A. PROCEDURE FOR REPAIR OF CENTRE PIVOT BOTTOM CROSS PALTE AS PER ARRANGEMENT SHOWN IN CLW DRAWING NO. 03/1/31/2.

B. SYMPTOMS OF POOR WELDING OF VERTICAL PLATES (ITEM NO.6) IN WAP1/WAP4 LOCOMOTIVES :

C. PROCEDURE FOR CHECKING THE HEALTH OF BOX SECTION FORMED BETWEEN TOP CROSS PLATE (ITEM NO.31) TWO VERTICAL CROSS PLATES (ITEM NO.5) AND MIDDLE PLATE (ITEM NO. 14) AS PER ARRANGEMENT SHOWN ON CLW DRAWING NO.03/1/31/2

RDSO. ELEC. DTE. SKEL-4433

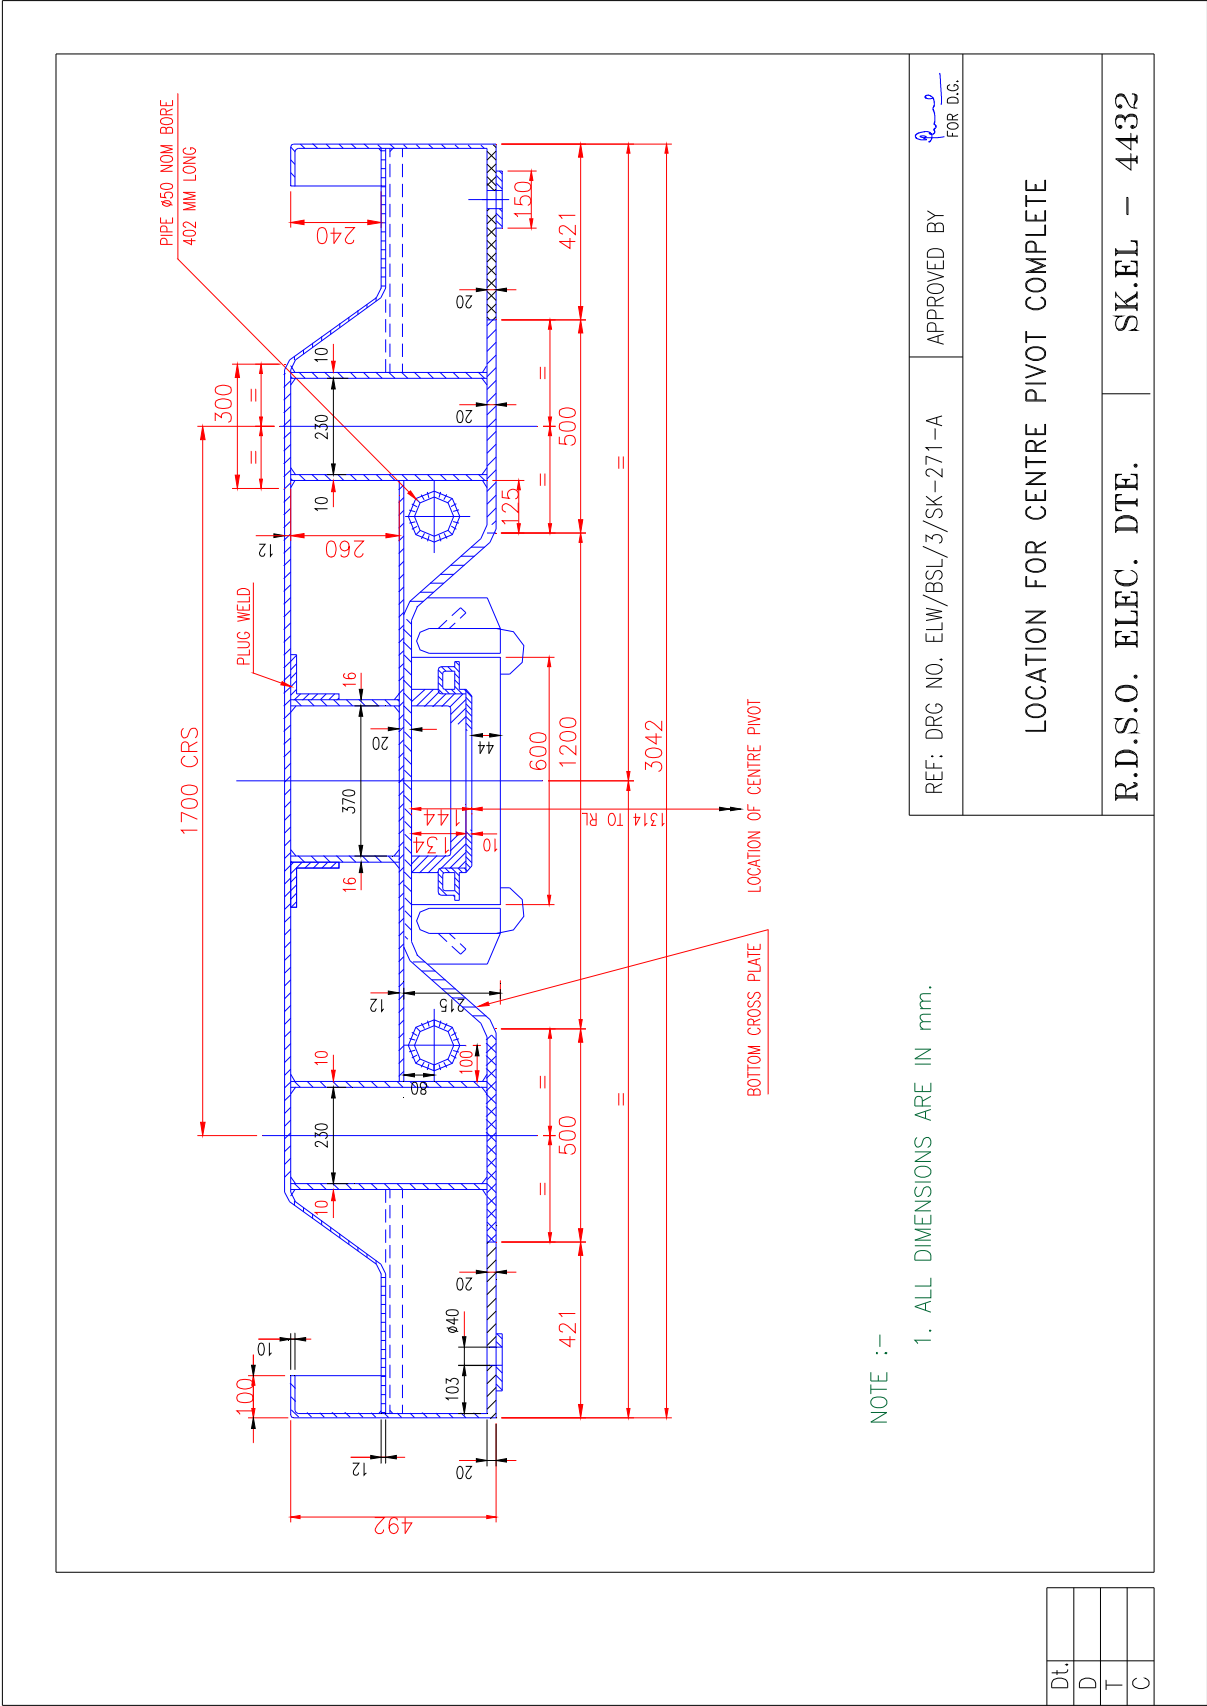
- iv) The plate should be heated at the bending locations by oxy-aceteleve flame and the necessary force required for bending is developed by mechanical turfer. The plate after bending from both ends should conform to enclosed drawing SKEL-4433.

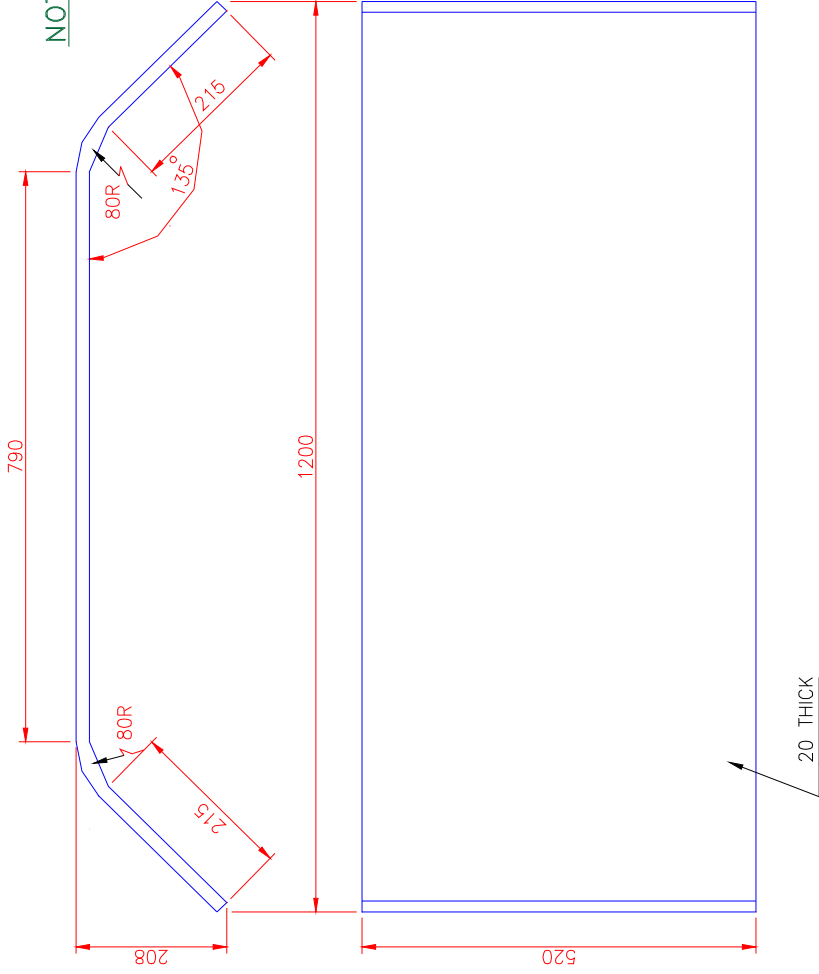
- C4. Suitable peep holes should be cut in the top cross plate (item No.3 of Drg. No. 03/1/31/2) to check the welding condition of vertical plates (Item No.6 of Drg. No. 03/1/31/2) with two vertical cross plates (Item No.3) and middle plate (item No.14). The welding of vertical plates (Item No.6) with two verticals cross plates (Item No.5) and middle plate (Item No.14) should be continuous on all sides.

- C5. If the welding of vertical plates (Item No.6) is continuous and proper on all the sides with two vertical cross plates (Item No.4) and middle plate (Item No.14) then peep holes may be suitably closed and all removed equipments should be fitted back and locomotives may be released for normal service.

- C6. If the vertical plates (Item No. 6) are found only tack welded with two vertical cross plates (Item No.5) & middle plate (Item No.14) then top cross plate should be removed carefully by weld cutting and continuous welding of vertical plates (Item No.6) with two vertical cross plates and middle plate should be properly done on all sides. The condition of plug welds between middle plate (Item No.14) and bottom cross plate (Item No.4) should also be checked and redone if required.

- C.7 Suitable angles of 20 mm thickness may be welded with the two vertical plates as per enclosed drawing SKEL 4432 so as to provide accessibility for welding with top cross plate (Item No.3).
- C.8 Now new top cross plate (Item No.3) should be placed in original position and to be welded carefully with the longitudinal beams (Item No.2), Vertical cross plates (Item No.5) and plug welded with angles provided on vertical plates (Item No.6).
- C9. Now all the removed equipments should be fitted back in the reverse and locomotives may be released for normal service.

SKETCH-A

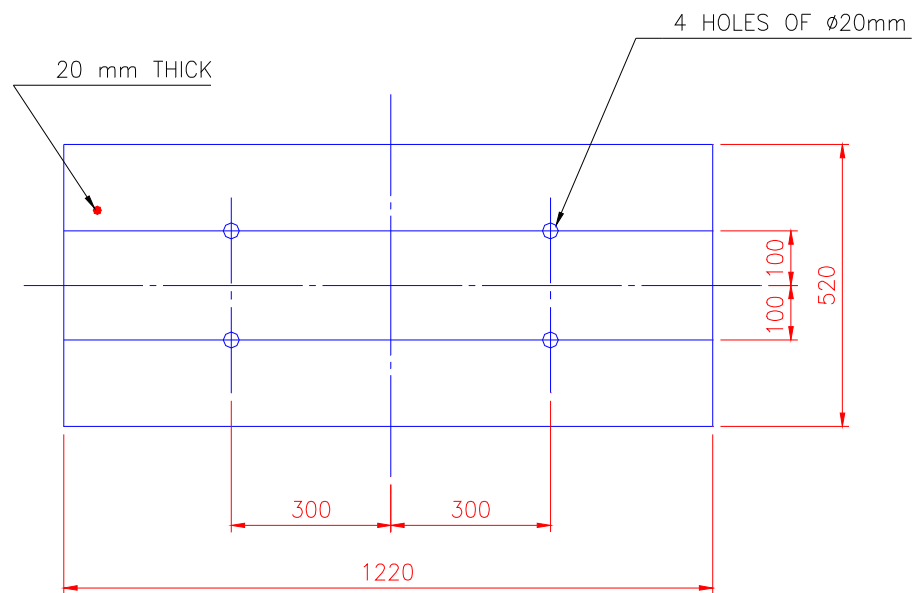
- ii) The plate is to be marked for four holes of M20 size as per enclosed sketch 'A' and these holes should be drilled.
 - iii) For bending of 20 mm plate in the required shape, a special bending fixture similar to ELW/BSL may be prepared. The plate should be mounted and fixed in the four holes to restrict the movement of plate during hot working.

SKETCH-B

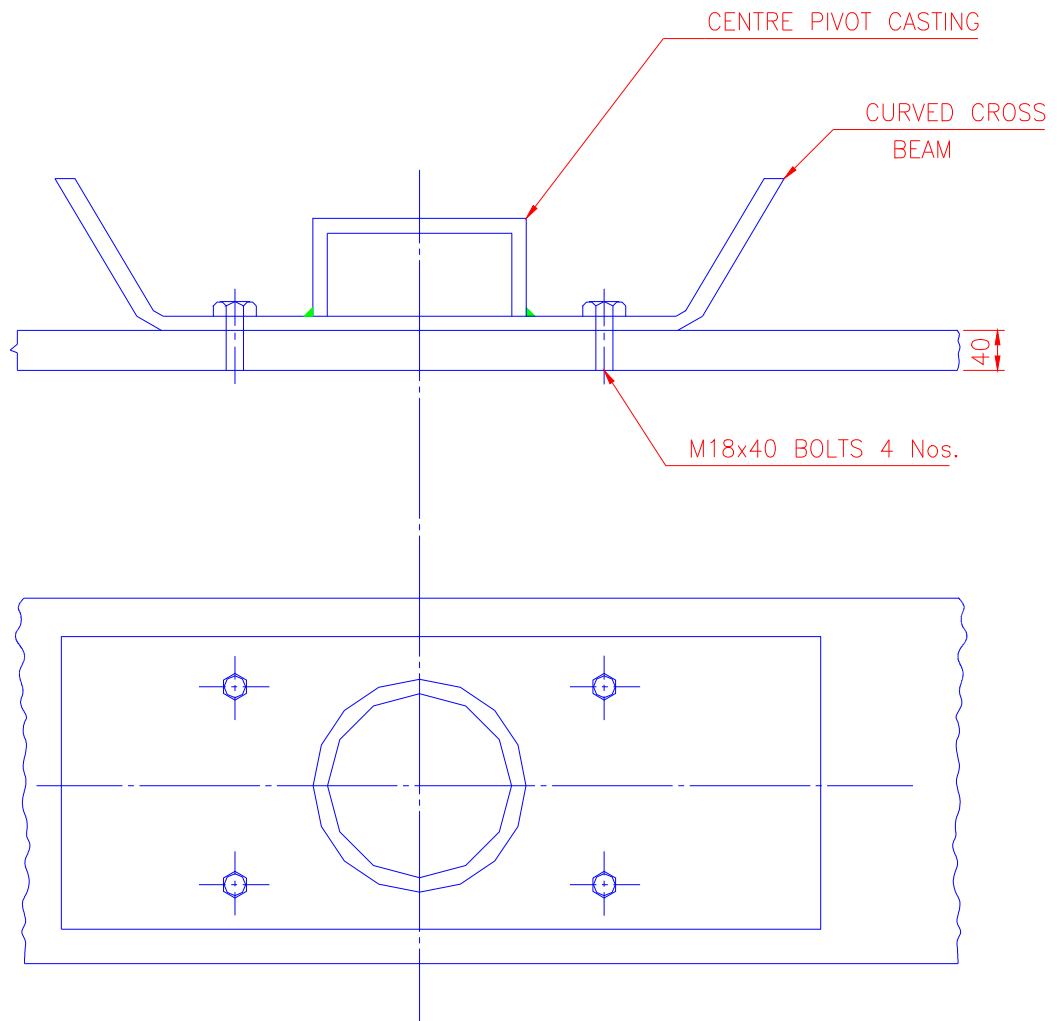
- A9. A simple welding fixture may be prepared as per sketch 'B' enclosed herewith as Annexure to avoid a warpage of cross beam plate during welding of centre pivot brackets. The welding fixture consist of 40 mm thick plate with M18 tapped holes in accordance with the four holes of the crossbeam plate.

- A10. The crossbeam plate is fixed on 40 mm plate with the help of M18 x 40 bolts as shown in sketch 'B'. The bolts are fully tightened before the commencement of welding on centre pivot and brackets. The tightness of fixing bolts should be checked frequently during continuos welding operation to prevent any distortion in the shape of the plate due to welding operation.
